SACRAMENTO COMMUNITY CENTER AUTHORITY

MINUTES OF THE MEETING OF THE GOVERNING BOARD  
OF  
SACRAMENTO COMMUNITY CENTER AUTHORITY

That that certain document entitled "Addendum #2", dated June 10, 1971, which is the second addendum to the specifications for the construction of the Sacramento Community Center Complex, 13th and 14th, J and L Streets, Sacramento, California, is hereby approved.

ADDENDA  
DRAWING  
**3**

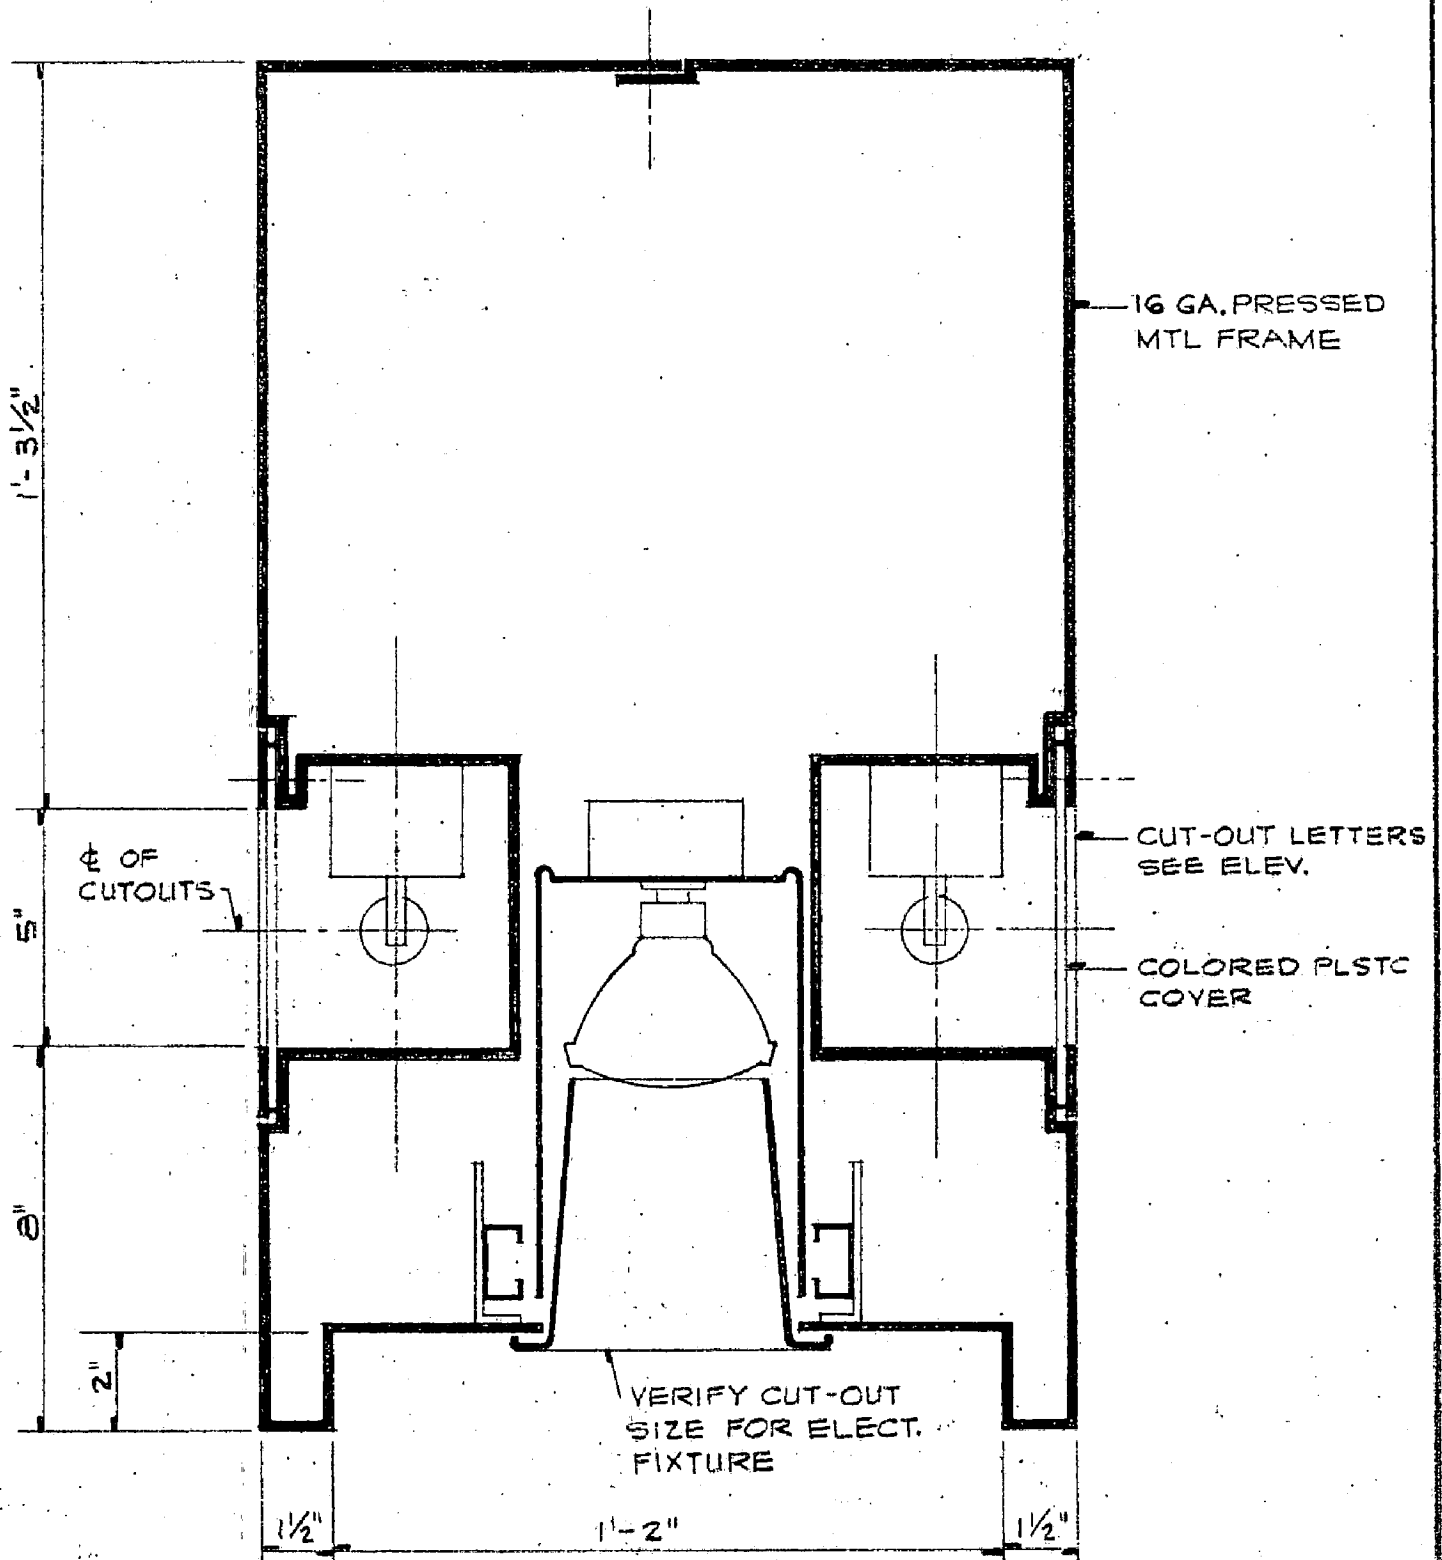
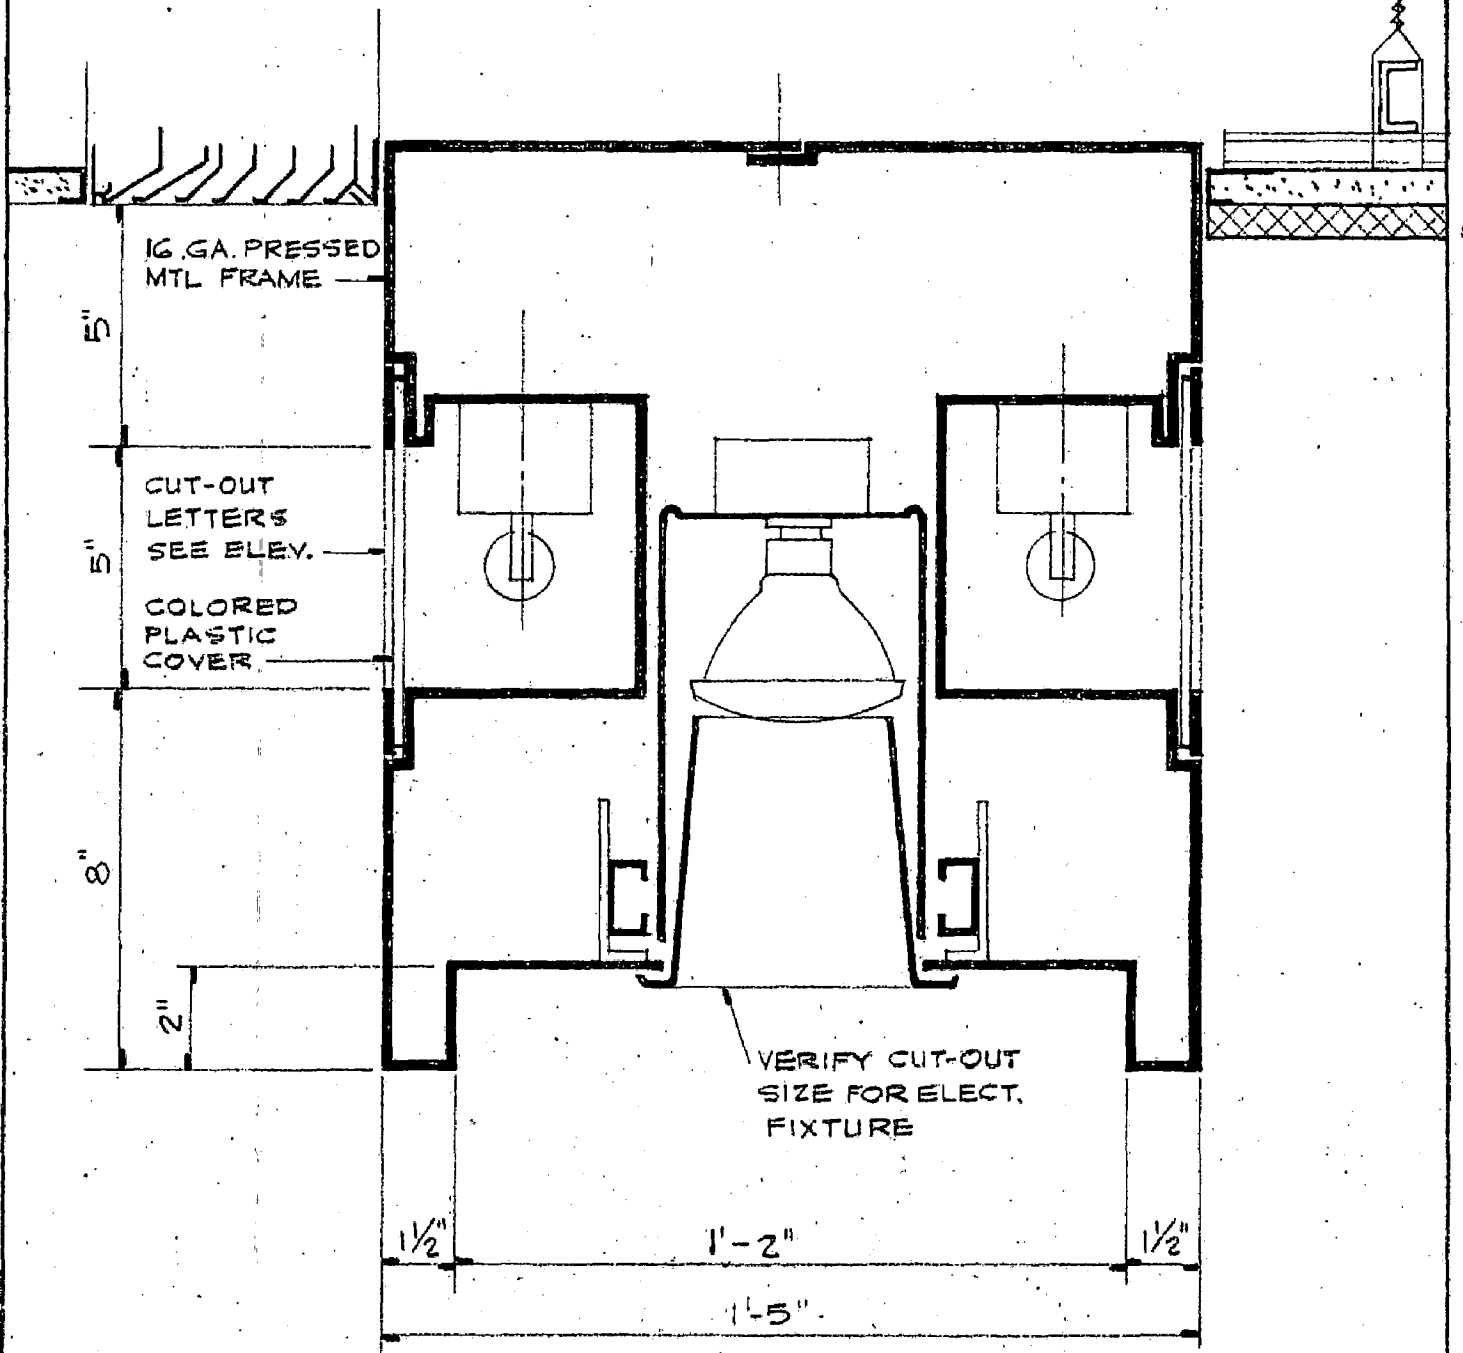
Addenda Drawings No. 3,4 and 5 delineate the pressed metal beam light fixtures at the Theater Promenades. If additional joints are required in fixtures, submit shop drawings to clarify desired locations.

ADDENDA  
 DRAWING

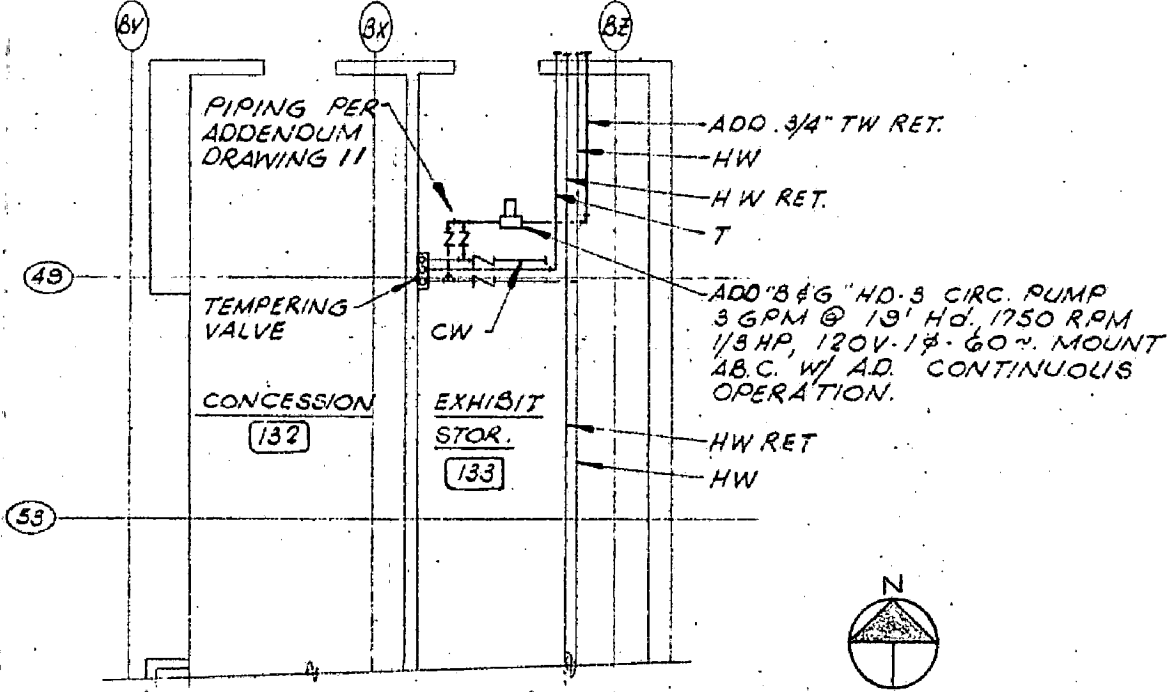
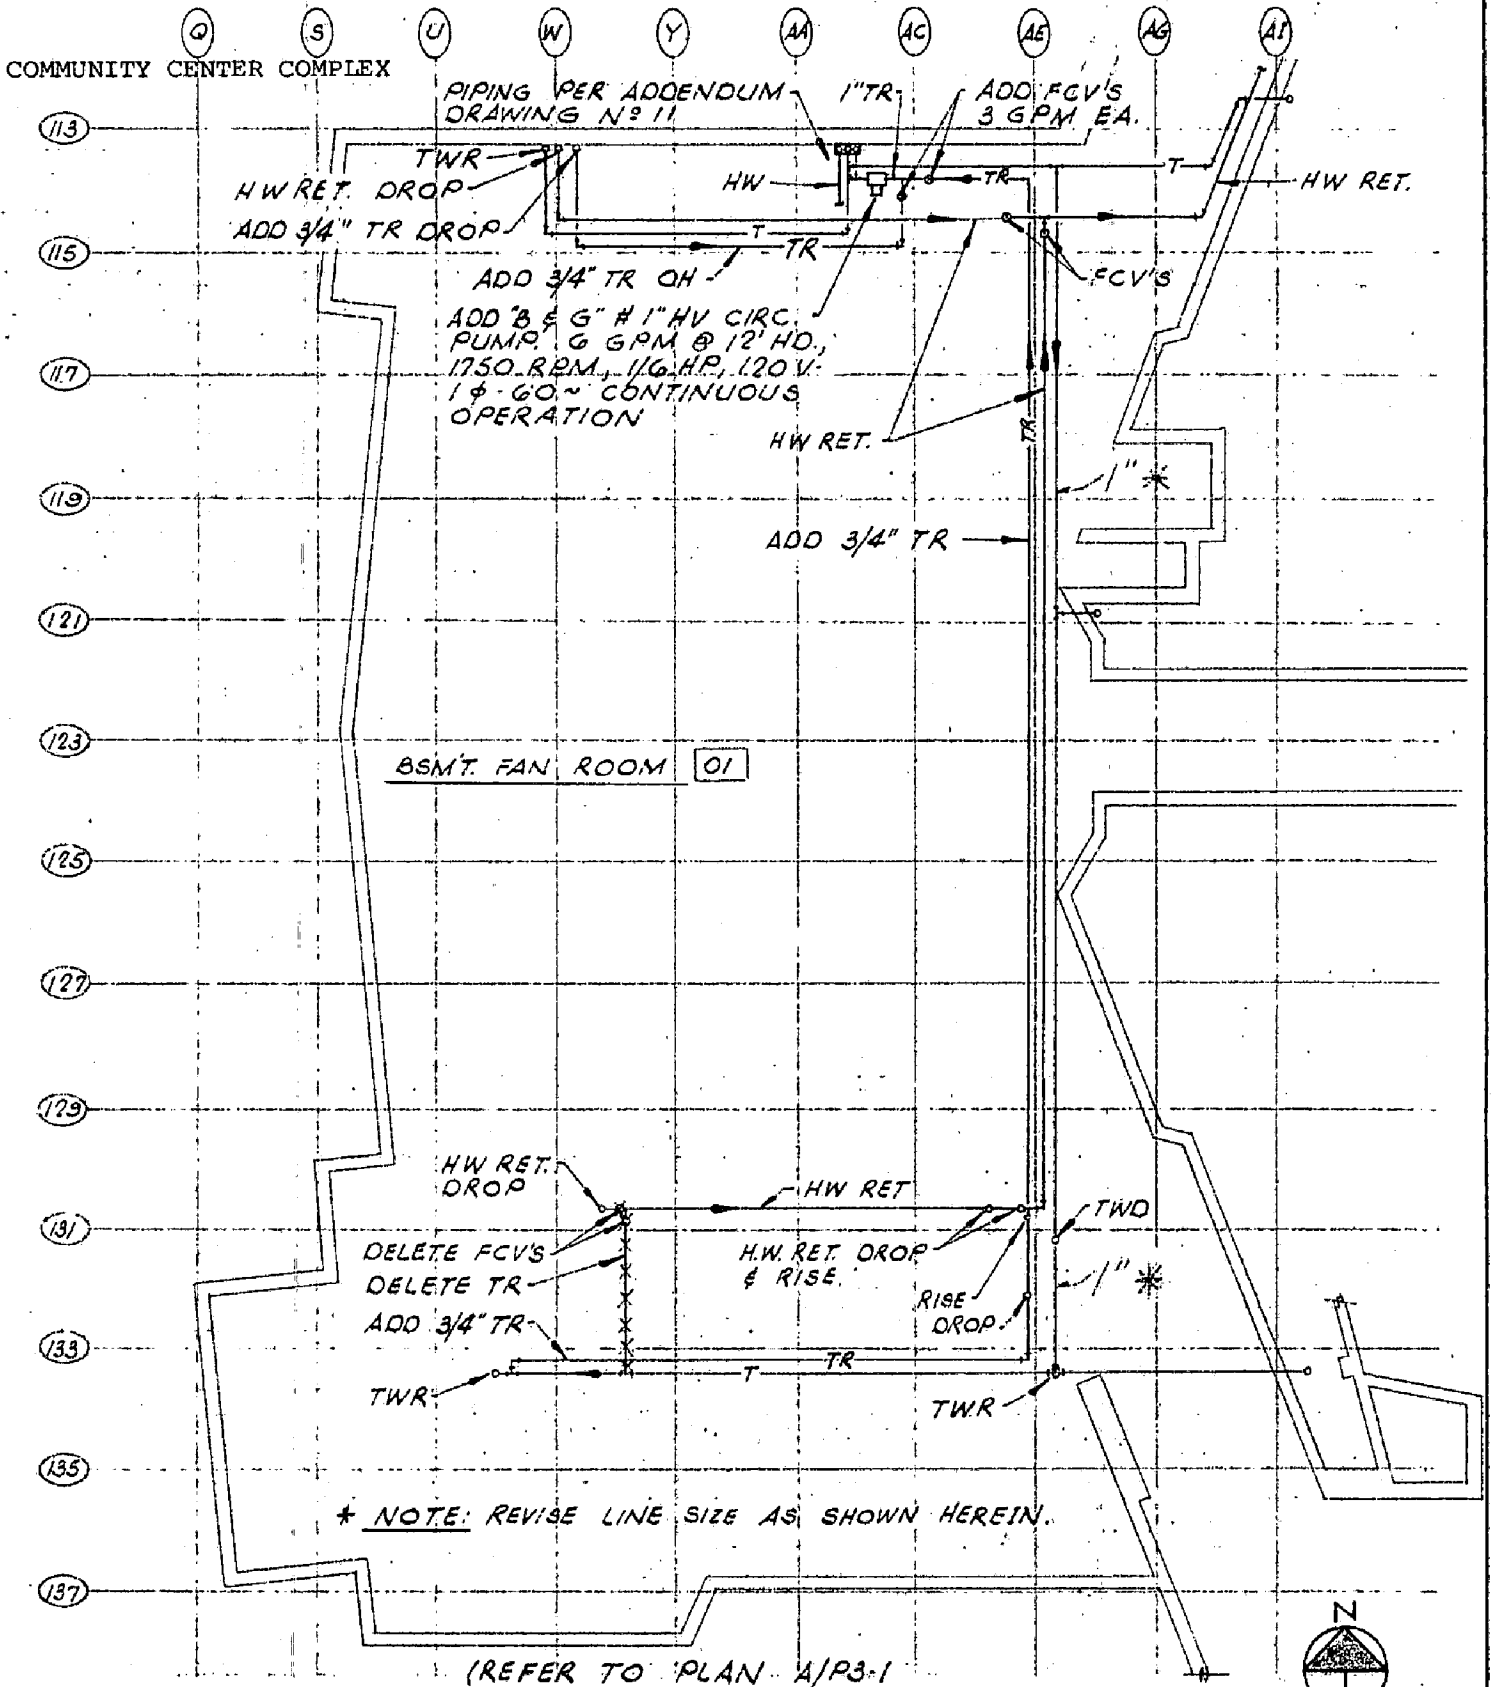
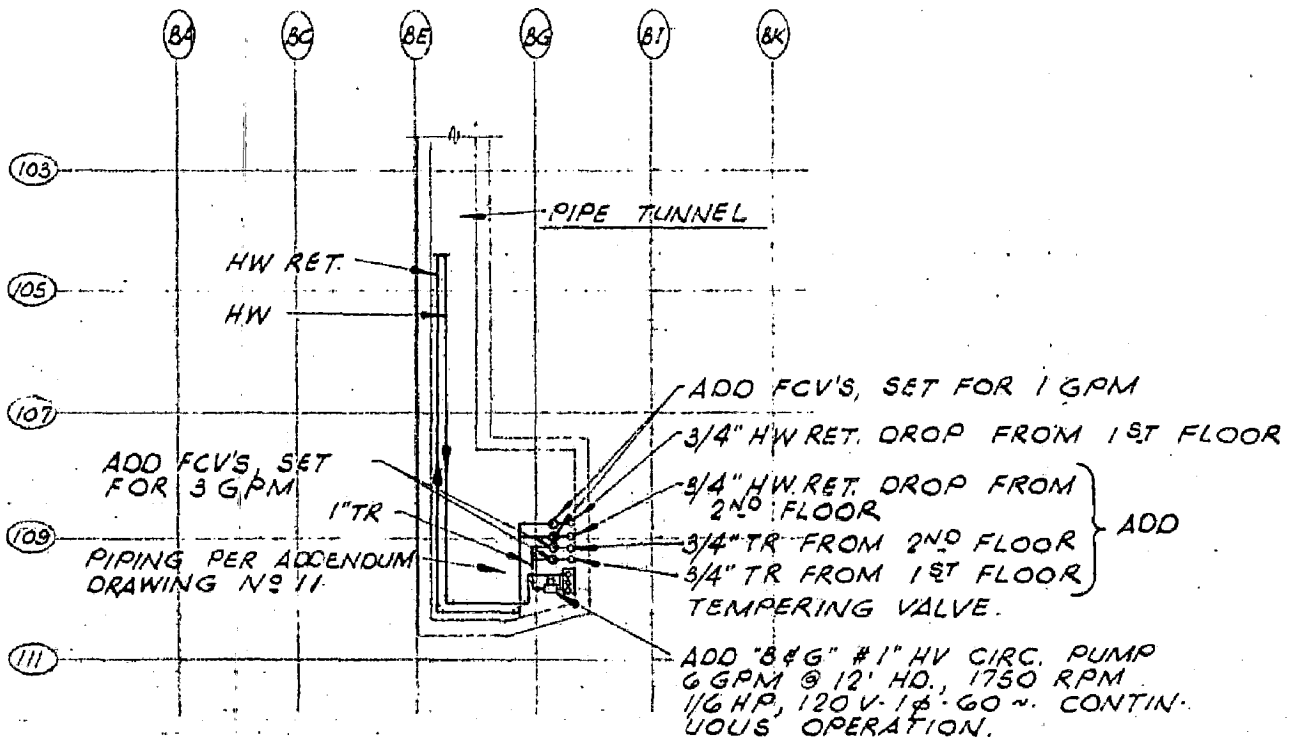
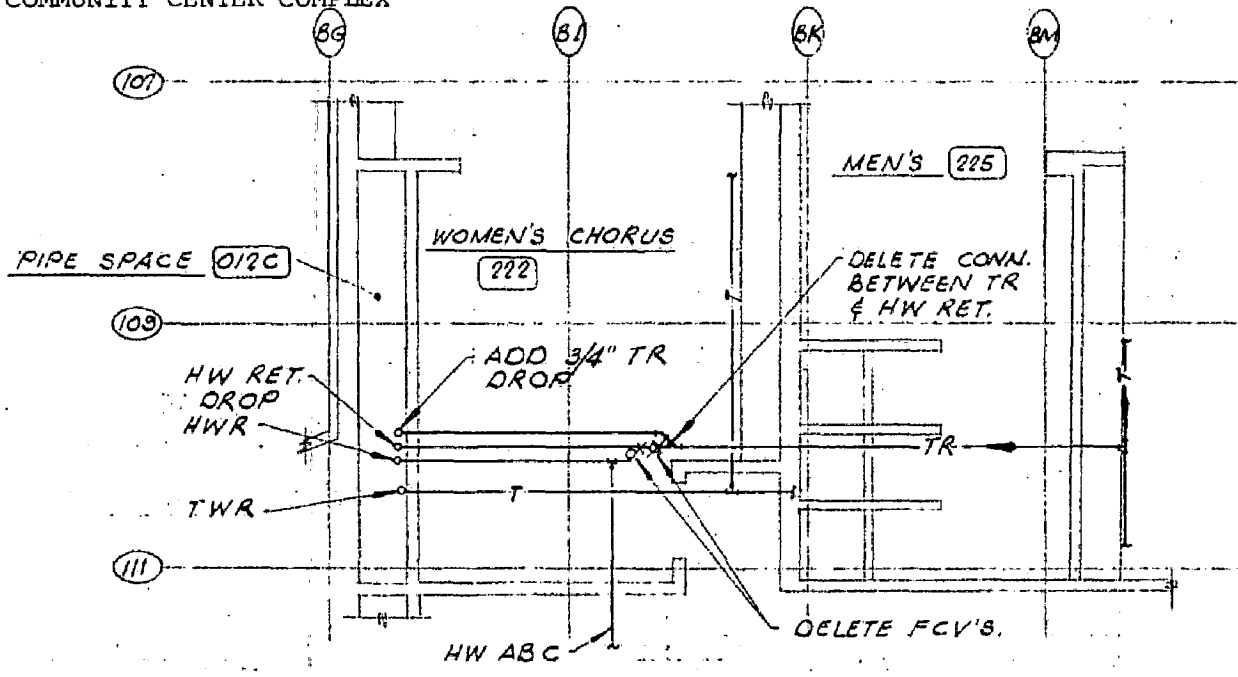
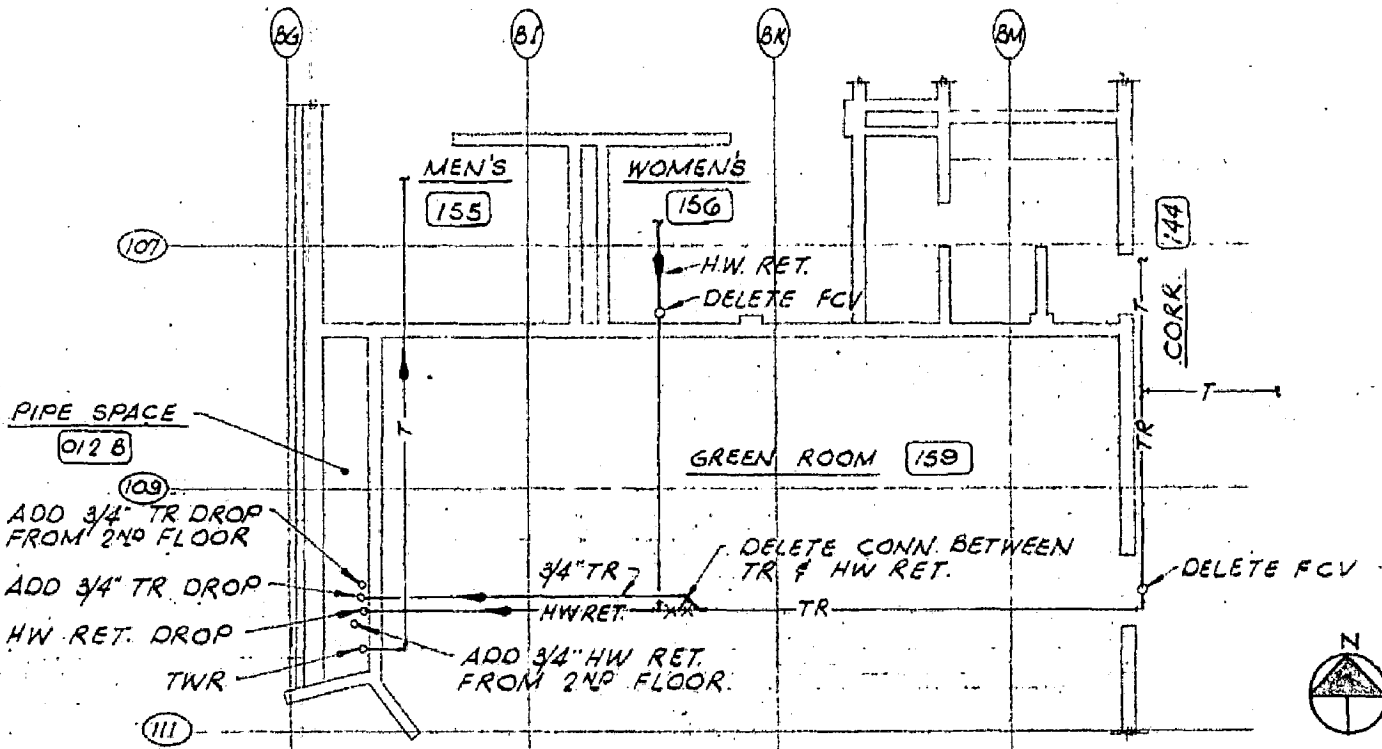
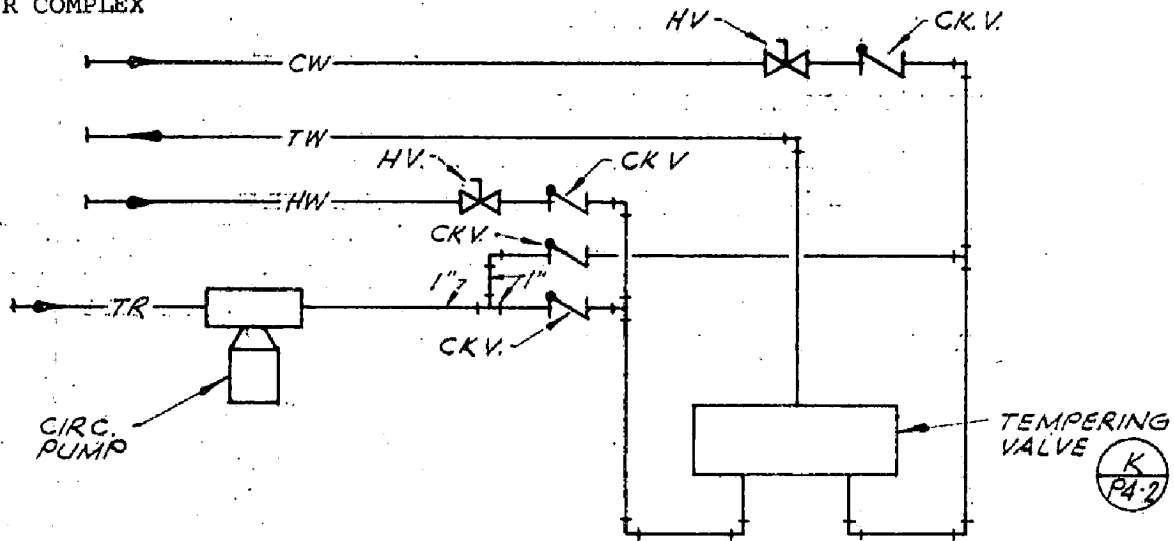
Addenda Drawings #6, 7, 8, 9, 10 and 11 - Show revisions to the tempered water system.

1. THE PURPOSE OF THESE DRAWINGS IS TO SEPARATE THE TW RETURN SYSTEMS FROM THE HW RETURN SYSTEM.
2. ALL OTHER WORK SHOWN ON ORIGINAL PLANS REFERRED TO SHALL REMAIN UNCHANGED.
3. REFER TO PLAN A, SHEET P2-1: DELETE 3/4" TR, CHECK VALVE & FLOW CONTROL VALVE CONNECTED BETWEEN 1" T & 1/4" HW RET. NEAR GRID LINES 77 & 8L.
